P 36033
A REPAIR

SEWAGE DISPOSAL SYSTEM

HOWARD COUNTY
BUREAU OF ENVIRONMENTAL HEALTH
992-2330

SUBDIVISION Kerger ROAD 5213 Kerger Road LOT 4
Parcel 523

PERMIT CARD

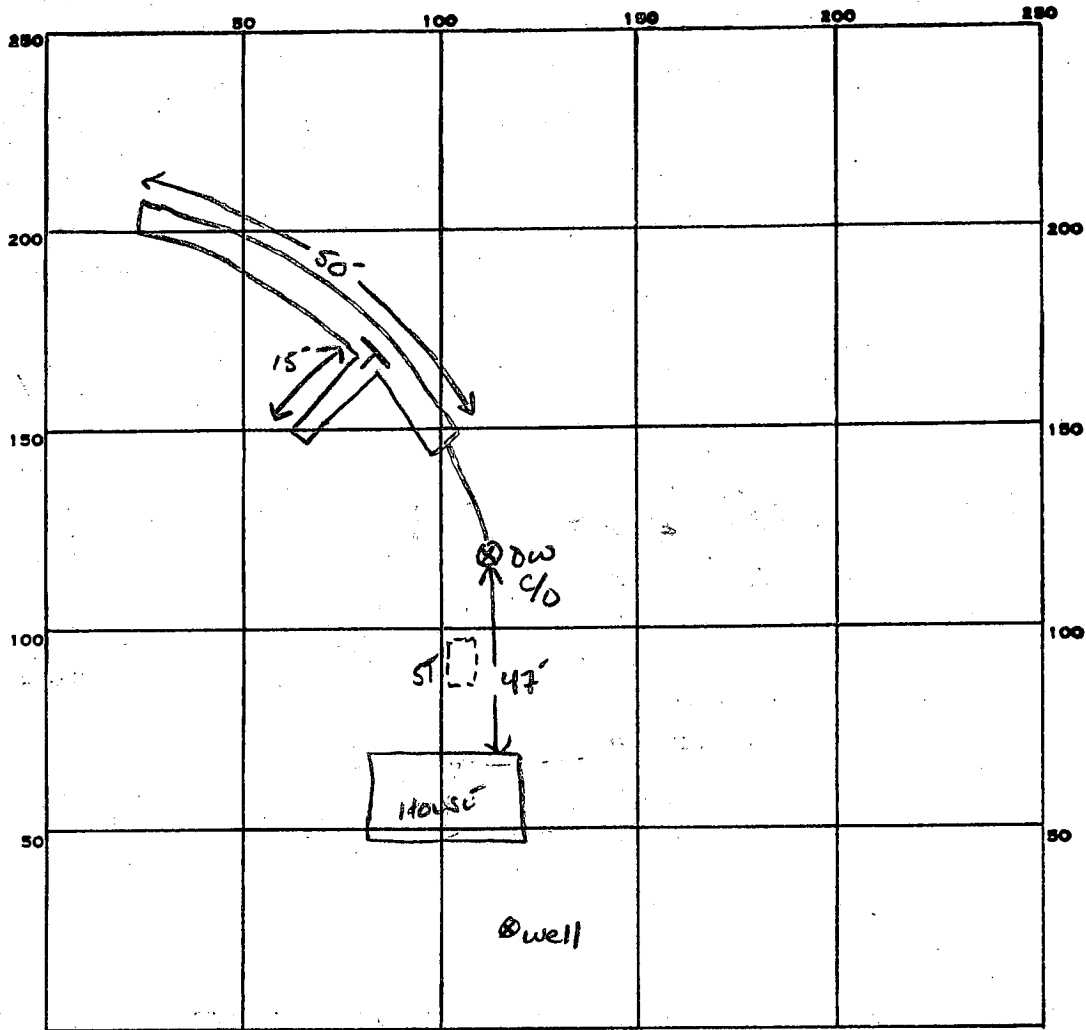
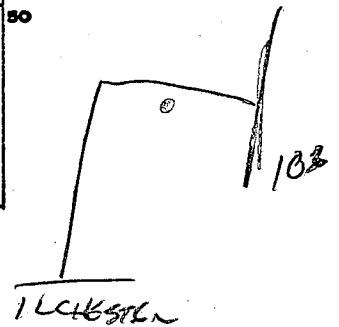
REMARKS 10-8-85 STONE INSURTER AS TRENCH DUG -> SIDE WALLS COLLAPSED;
OK TO COVER ALL WORK.
